To: Plan Holders for Improvements to the
Salina Regional Airport
Salina, Kansas
New Aviation Bulk Fuel Facility

Transmitted herewith is Addendum No. 4 to the Contract Documents, Plans, and Specifications dated April 17, 2023 for Improvements to the Salina Regional Airport, Salina, Kansas, New Aviation Bulk Fuel Facility.

**ADDENDUM NO. 4
TO
CONTRACT DOCUMENTS, SPECIFICATIONS AND PLANS
FOR IMPROVEMENTS TO THE
SALINA REGIONAL AIRPORT
SALINA, KANSAS
AIP NO. 3-20-0072-047/049**

M-210 – Mechanical Sheets – These sheets have been updated to include a schematic of the clay treater skid.

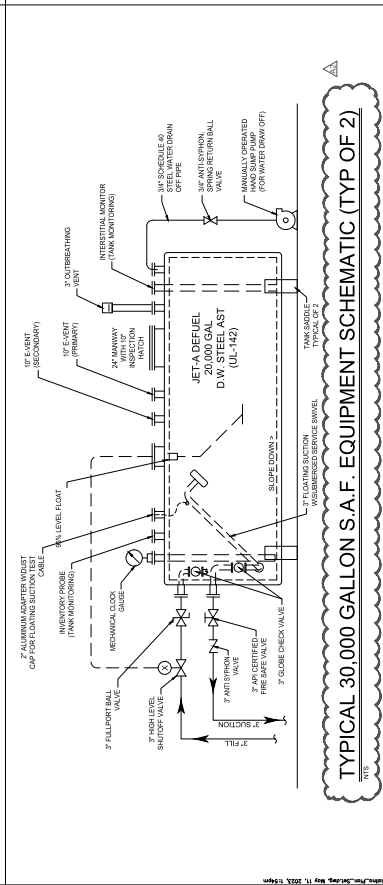
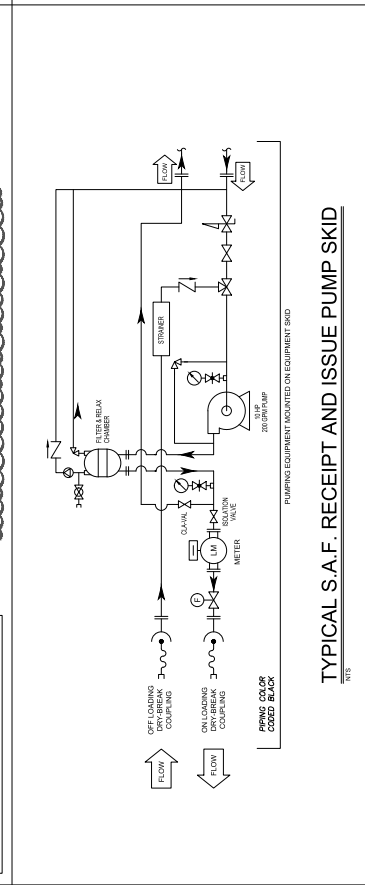
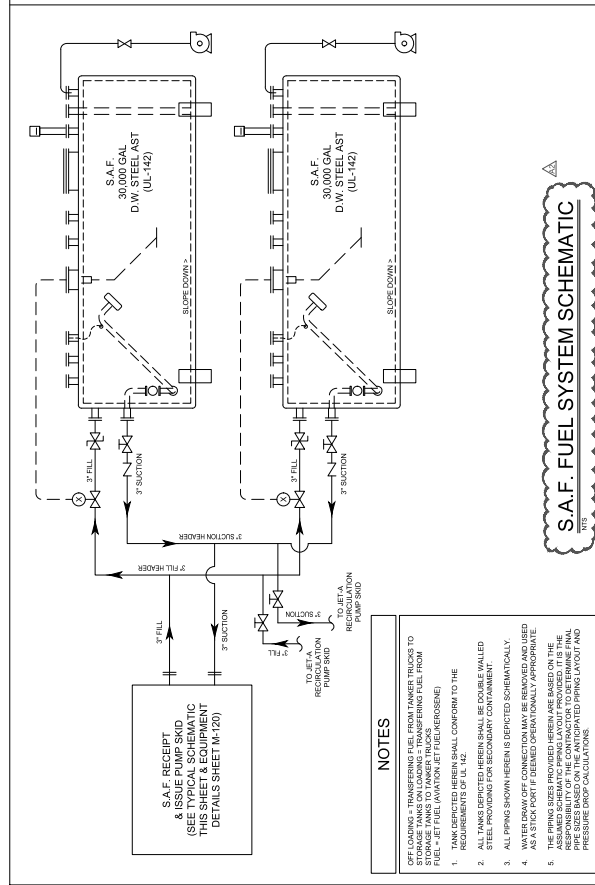
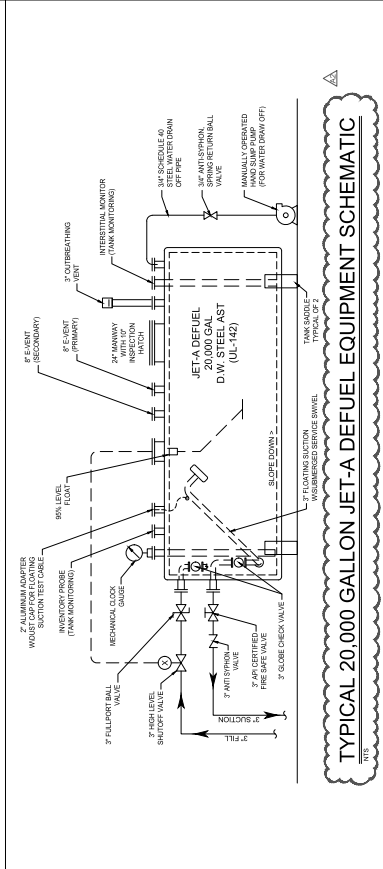
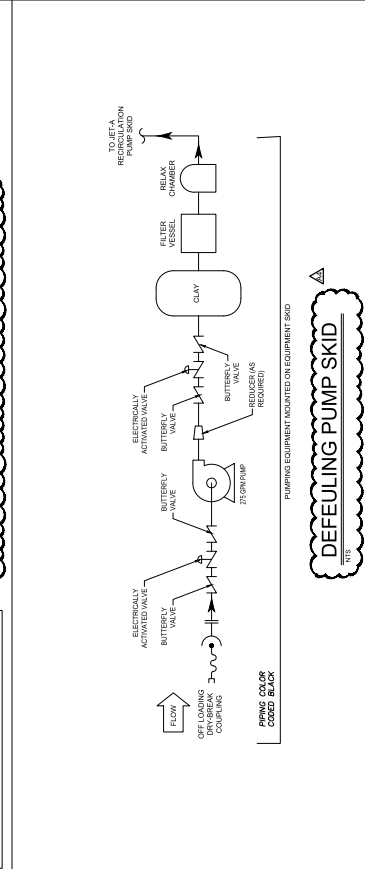
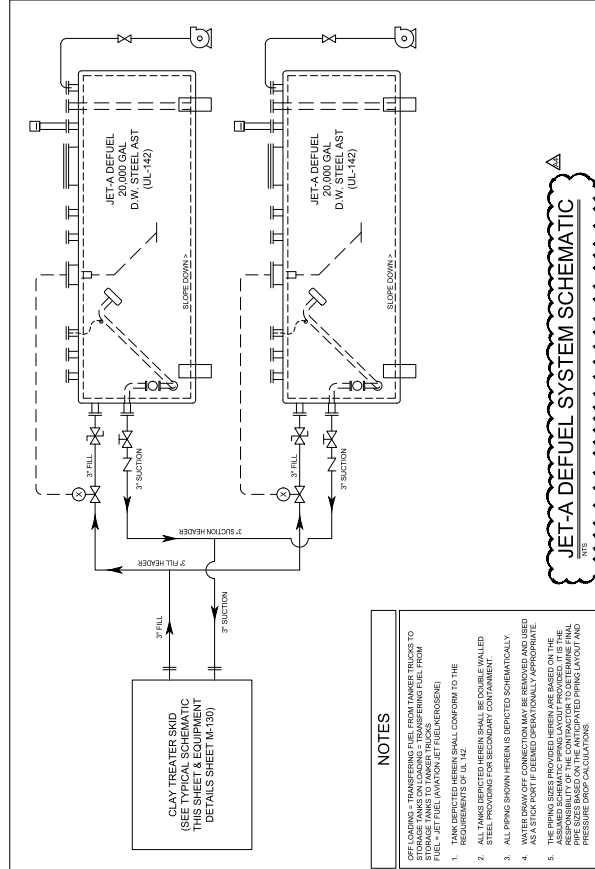
Question: Is a pump required for the Clay Treater Skid? The following discrepancies exist in the plans and specifications:

- ☐ 00 01 20 Para 1.01.F.9 describes a Clay Treater pumping system w/ a 4" PD pump.
- ☐ M-130 does not show a pump.
- ☐ M-210 does not show a pump but rather shows the DEFUEL tank suction header running to the JET-A RECIRC SKID.
- ☐ There is no schematic for the Clay Treater skid.
- ☐ There is no specification for the Clay Treater vessel.
- ☐ D-100 shows suction and fill lines to/from the DEFUEL tanks and CLAY treater skid. It does not show the DEFUEL suction line running to the JET A RECIRC skid.
- ☐ E-415 shows 480V pump power conduit to the Clay Treater Skid, re: Conduit # 106 derived from Power Panel A, CKTs 19-23
- ☐ E-700 shows a 20 hp Clay Treater pump motor.
- ☐ E-710 shows CLAY TREATER STARTER #4.

Answer: Yes. The Clay treater skid basis of design should be a 275 GPM pump. This skid will be isolated from the other jet piping.

- Clay treater pump is Acknowledged. Pump selected by Contractor must be sized to accommodate the performance required to work with system as defined in contract plans.
- Acknowledged, the contractor should consider a pump necessary and include this in their bid.
- The basis of design for the clay treater skid should be considered an F-series Clay treater as Mfg by Facet. Of course, contractors are able to provide approved equals for consideration.
- The clay treater schematic on sheet m-210 has been updated to include a schematic of the clay treater skid.
- E-415 Correct.
- E-700 – The pump motor defined in the electrical is a place holder and may be oversized to assure electrical loading assumed is conservative.
- E-710 – Acknowledged.
